Re: Appeal of FEMA's May 2015 preliminary Flood Insurance Rate
Maps for the East Side of Ocean Drive, South Bethany

I respectfully submit this appeal of FEMA's May 2015 Preliminary Flood Insurance Rate Map for the east side of Ocean Drive, South Bethany (the "2015 Preliminary FIRM"). As addressed below, the 2015 Preliminary FIRM is scientifically and technically incorrect in a number of respects that result in the 13 foot base flood elevation (BFE) assigned to homes on the east side of Ocean Drive (referred to hereinafter as the "Ocean Drive homes") being incorrect.¹ As also discussed below, the 2013 Preliminary FIRM (defined below), which assigned a BFE of 10 feet to Ocean Drive homes, is scientifically and technically correct.

Dune Cases - Retreated or Removed

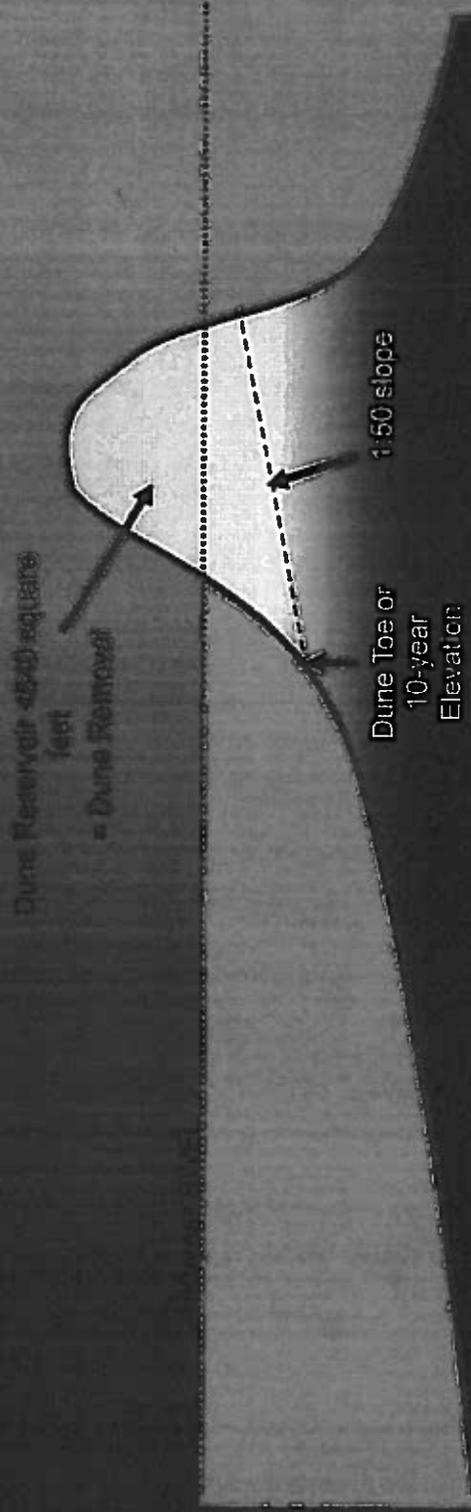
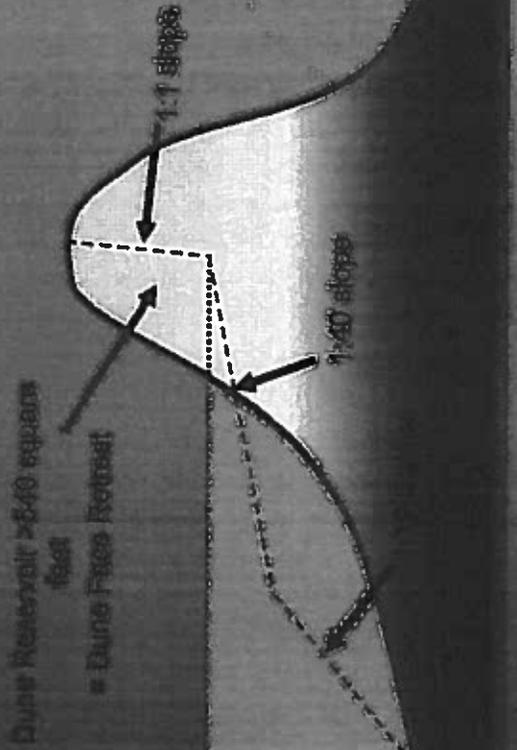
Page 6 of the FEMA Explanation Materials (Exhibit B) reflects how the dune removal or retreat determination is made. Exhibit C also reflects how the dune removal or retreat determination is made as well as application of the 1:50 erosion slope for removal. As noted above, FEMA and RAMPP have been inconsistent in their statements regarding whether the dunes present in South Bethany were treated as a removal or retreat case for the analysis underlying the 2015 Preliminary FIRM. To the extent they were treated as a retreat case, such treatment is scientifically and technically incorrect since there is no plausible analysis under which to the 540 square foot rule would be met and there is no scientific, technical, or other basis that supports deviation from the 540 square foot rule.

Exhibit D

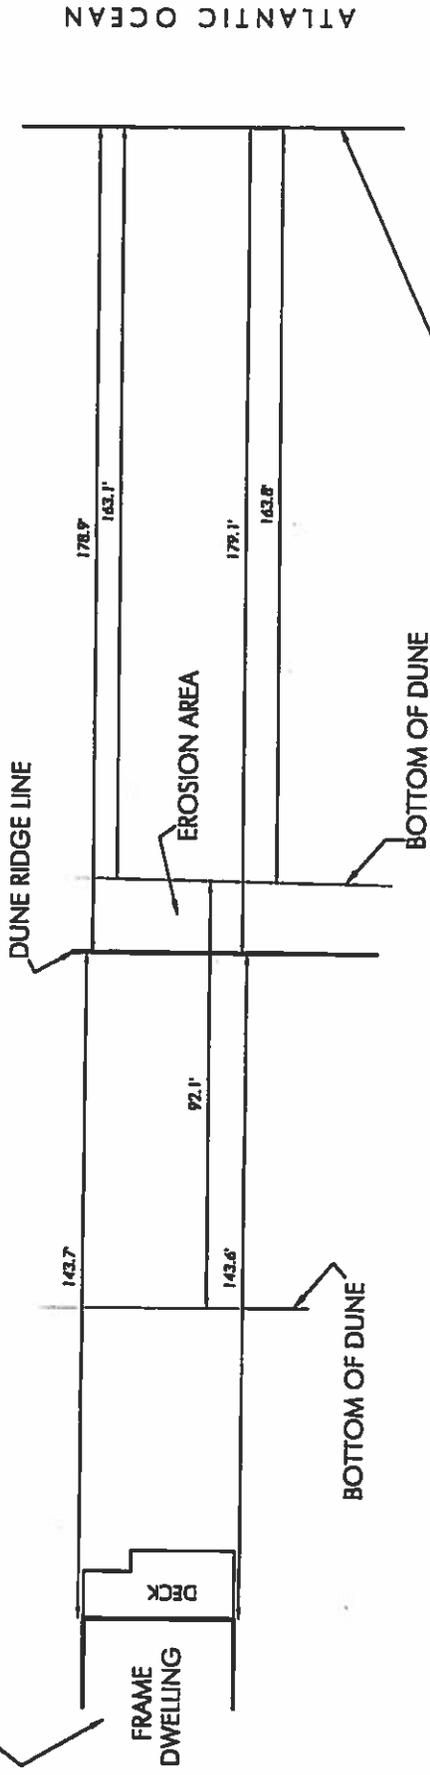
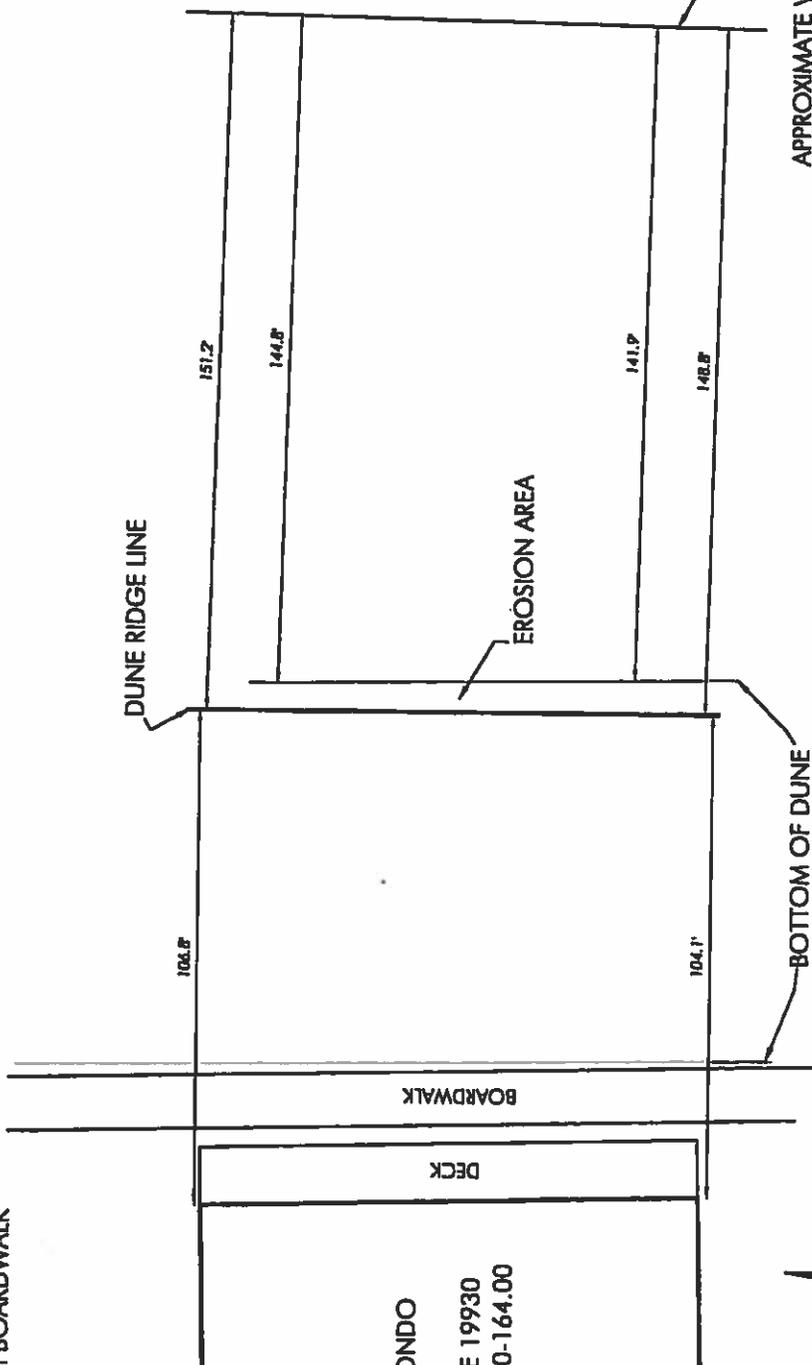
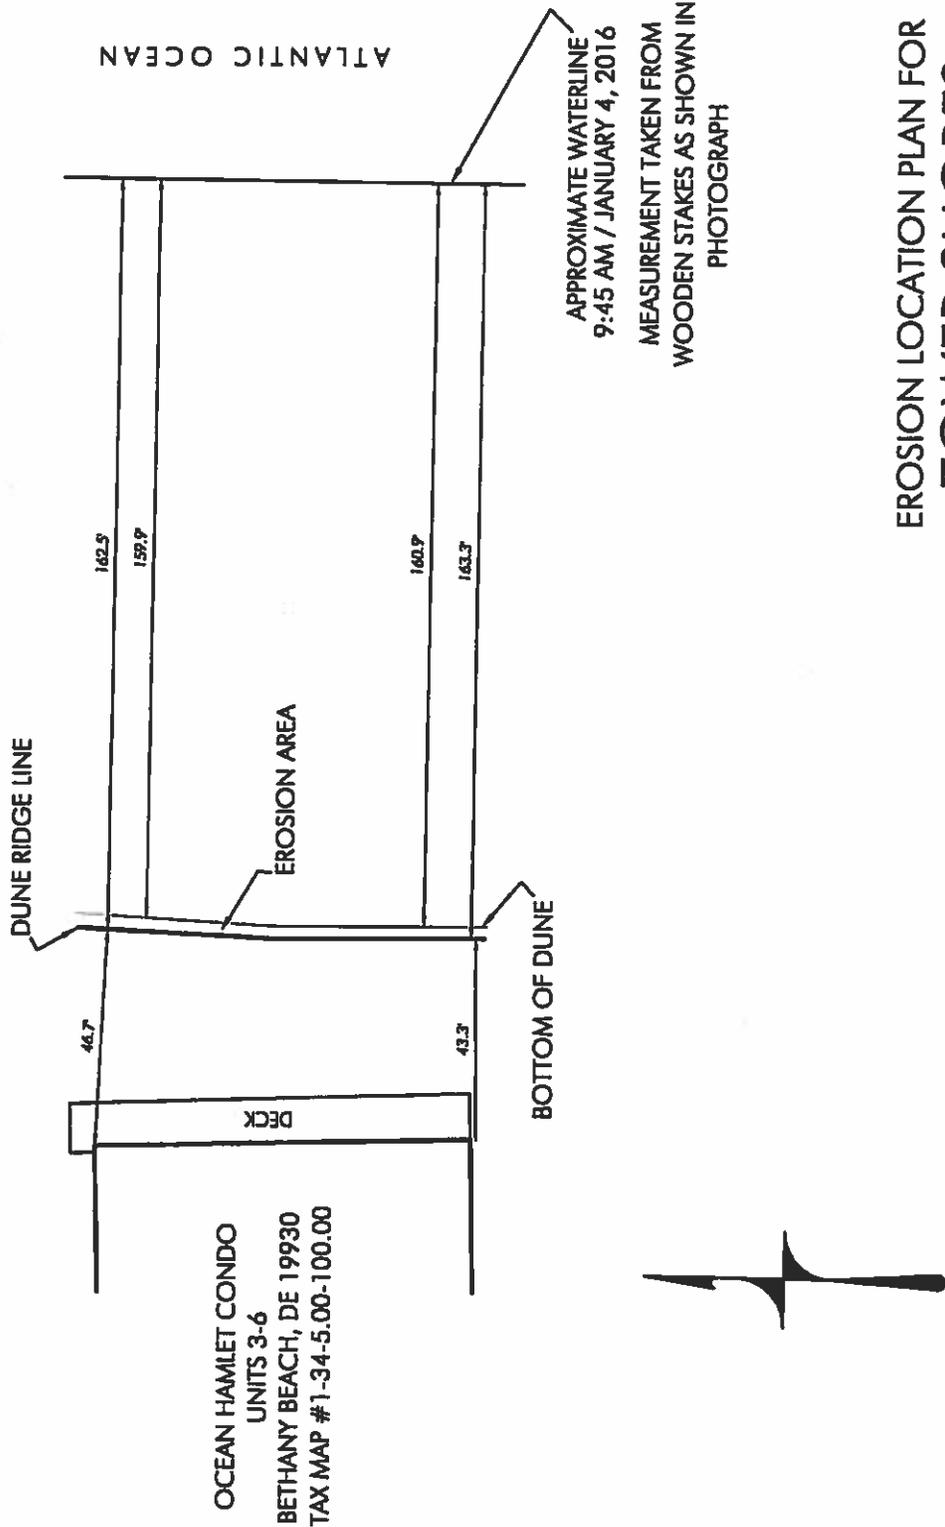
Attached as Exhibit D is a survey and related photos reflecting the following information for (a) 302 N. Ocean Drive, South Bethany (my home), (b) the "Ocean 8" townhouses adjacent to Campbell Place in Bethany Beach, and (c) the Ocean Hamlet condominiums in Tower Shores North Bethany, all as of January 4, 2016: location of the shoreline, toe of the dune, ridge of the dune, and location of the residential structures. The beach and dune profiles reflect their current state following a major storm that hit the Delaware shore during early October 2015. As reflected by the survey and photos, all three locations show similar dune scarping, although because the Tower Shores location has a much smaller dune, the vertical height of the scarping is much lower. The location of the peak erosion point of the dunes is approximately 143 feet from the residential structure at 302 N. Ocean Drive, 105 feet from the residential structure in Bethany Beach, and 45 feet residential structure in Tower Shores. Thus, the storm erosion reached much closer to the Bethany Beach and Tower Shores residential structures than the South Bethany

structure. The Bethany Beach and Tower Shores residential structures are also substantially closer to the shoreline than the South Bethany residential structures (approximately, 255 feet for Bethany Beach, 210 feet for Tower Shores, and 305 feet for South Bethany).

The thick yellow line is the 12ft contour.

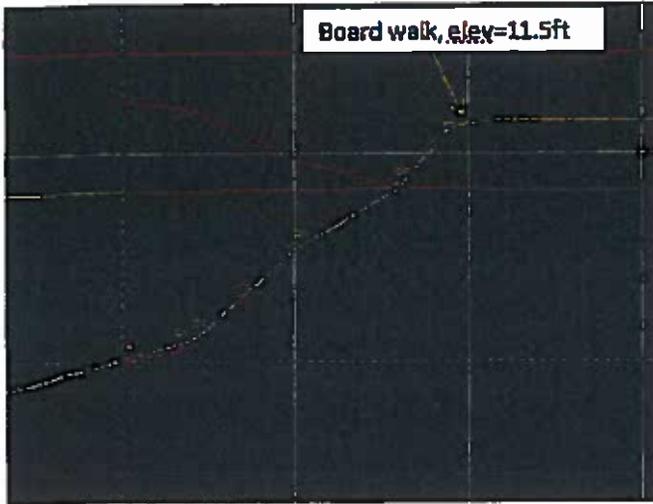
Looks like there is some dune line starting to form there although not very pronounced. I know in other areas, such as on Long Island in Long Beach, we have taken the approach of including the broad walk in the VE but no further.

I forgot to mention that we don't have PFD line delineated for the board walk area. and we did not perform erosion either. Runup was performed for some transects in that area. I think it is reasonable to include the whole board walk in V zone but at a stretch to add the seaward portion of the oceanfront buildings.

Christine,
The board walk in Rehoboth Beach does have elevation of 12ft at some places and 10ft at other places in our topo. The board walk comes in and out of the preliminary floodplain and we only have the seaward side of a couple of buildings in VE zone right now.

We are planning to add the whole boardwalk to VE zone and will evaluate if should include some of the buildings based on contour and modeling results.

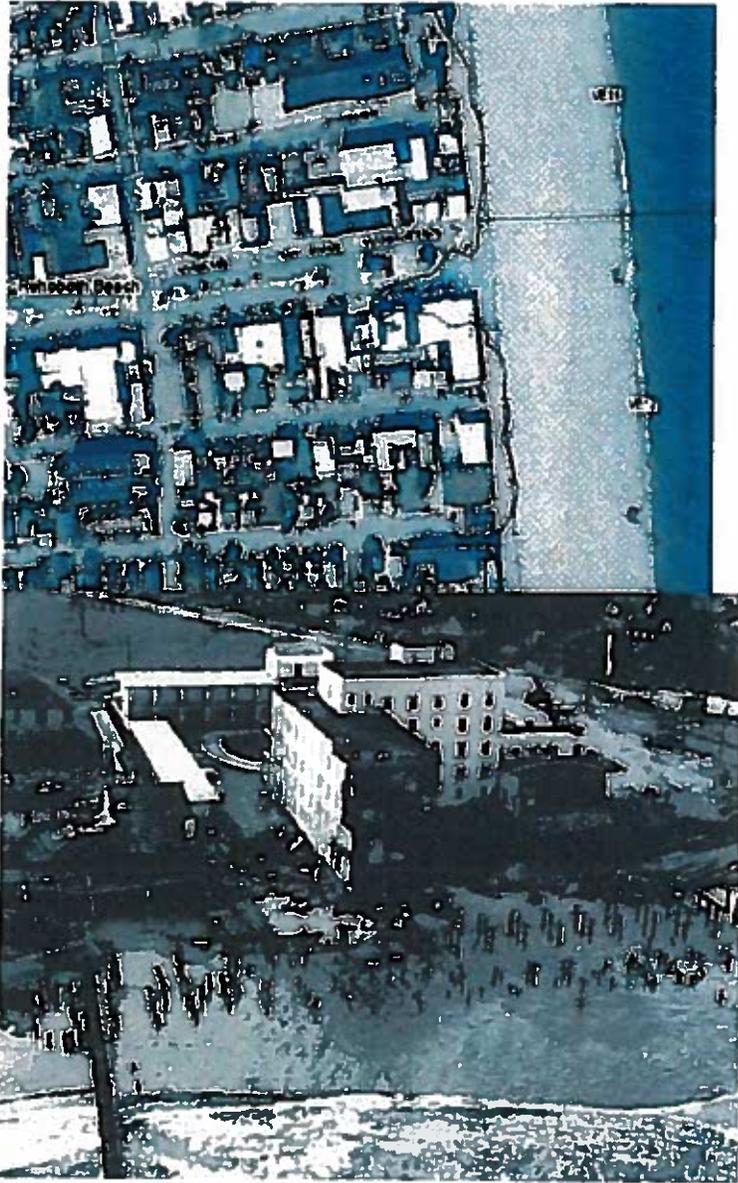
Issue – portions of the Rehoboth Beach boardwalk are being completely removed from the SFHA

Discussion – The Rehoboth boardwalk was mostly destroyed by storms in March 1962 and January 1992, which likely did not exceed 1% return criteria. We have traced this problem to the LiDAR data, which did not appear to remove the boardwalk from the data, therefore the boardwalk surface elevation 12 was probably modeled as bare earth. In fact the grade underneath the boardwalk is several feet lower than the surface of the boardwalk. The photograph on the right shows boardwalk destruction in 1962 roughly (slightly north of) in the area of the map to the left

Issue – portions of the southern portions of Dewey Beach are being completely removed from the SFHA, and the 500 year floodplain.

Discussion – Ocean flooding flowed over the dunes, across coastal highway and into Rehoboth Bay in storms in March 1962 and January 1992, which likely did not exceed 1% return criteria. The photo on the right shows post-storm damage and overwash in

Potential Solution – move the VE zone west to include all of the boardwalk and the seaward portions of oceanfront buildings, which were also damaged in 1992.

Potential Solution – Continue to show these areas as AO depth 2 feet which seems to be consistent with observed conditions.

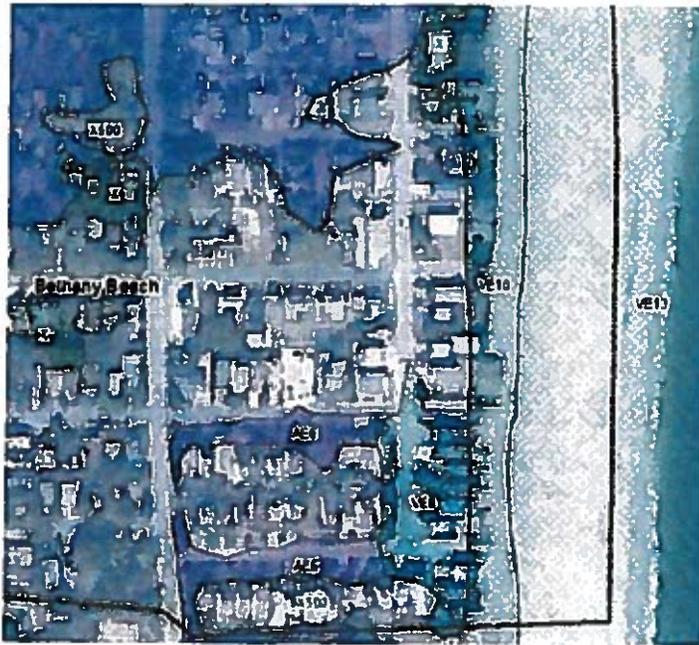
Issue – The oceanfront VE zone BFE's in Dewey Beach Jump from 12 to 17 in one area

Discussion – We are not aware of any storm observations or data that would indicate higher BFEs are appropriate on this reach of shoreline.

Issue – portions of the what is referred to “North Bethany” (unincorporated neighborhoods between The Town of Bethany Beach and Indian River Inlet) are being completely removed from the SFHA

Discussion – Ocean flooding flowed over the dunes, across coastal highway and into Indian River Bay in a storm in March 1962, which likely did not exceed 1% return criteria. The photograph on the right shows small building washed across coastal highway by ocean surge flooding in exactly the location of the DFIRM map on the left. While coastal highway IS in the SFHA in the preliminary data, the preliminary data seems to under-predict the ocean surge flooding which was sufficient to wash buildings off their foundations in this area.

Potential Solution – Continue to show these areas as AO depth 2 feet which seems to be consistent with observed conditions.

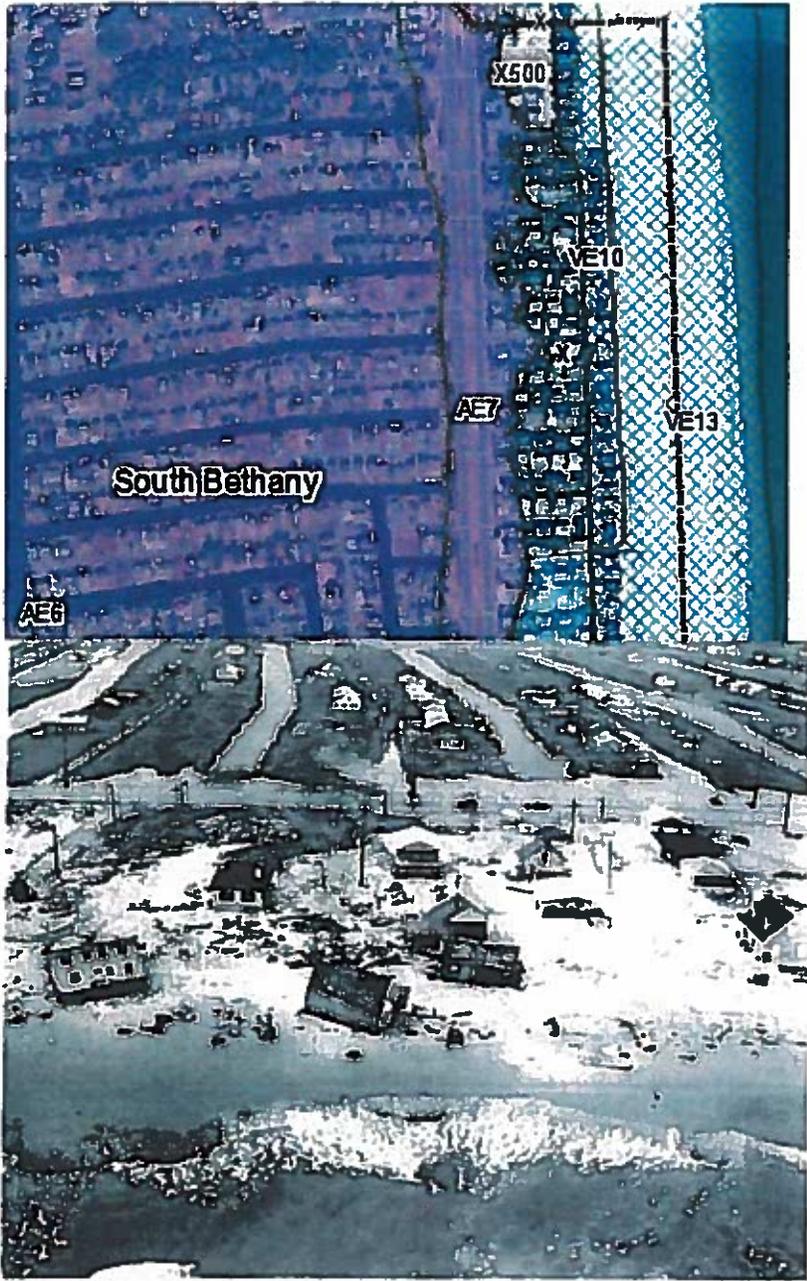
Issue – portions of Bethany Beach are being completely removed from the SFHA, and are shown as X or X500.
Discussion – Ocean flooding flowed over the dunes, as far inland as coastal highway in storms in March 1962 and January 1992, which likely did not exceed 1% return criteria. The south half of the oceanfront block of Bethany is quite flat an almost basin – like with slightly higher elevations immediately to the west of coastal highway. This area tends to hold 1-2 feet of shallow flooding in severe coastal storms. The photo in the right is taken looking south on coastal highway into the area shown on the map to the left.
Potential Solution – The area is shown as AE on the current maps, and this, or AO depth 2 might be a workable solution.

Issue – portions of South Bethany Beach are being completely removed from the SFHA and 500 year floodplain.
Discussion – Ocean flooding flowed over the dunes, across coastal highway and into Assawoman Bay in storms in March 1962 and January 1992, which likely did not exceed 1% return criteria. The picture to the right shows that overwash in South Bethany in roughly the area of the map on the left
Potential Solution – Continue to show these areas as AO depth 2 feet which seems to be consistent with observed conditions.

Issue – Small areas between South Bethany Beach and Fenwick Island are being completely removed from the SFHA.

Discussion – This removal is quite surprising. The Barrier Island is at its narrowest in these areas, and Ocean flooding flowed over the dunes, across coastal highway and into Assawoman Bay in storms in March 1962 and January 1992, which likely did not exceed 1% return criteria.

Potential Solution – Continue to show these areas as AO depth 2 feet which seems to be consistent with observed conditions.
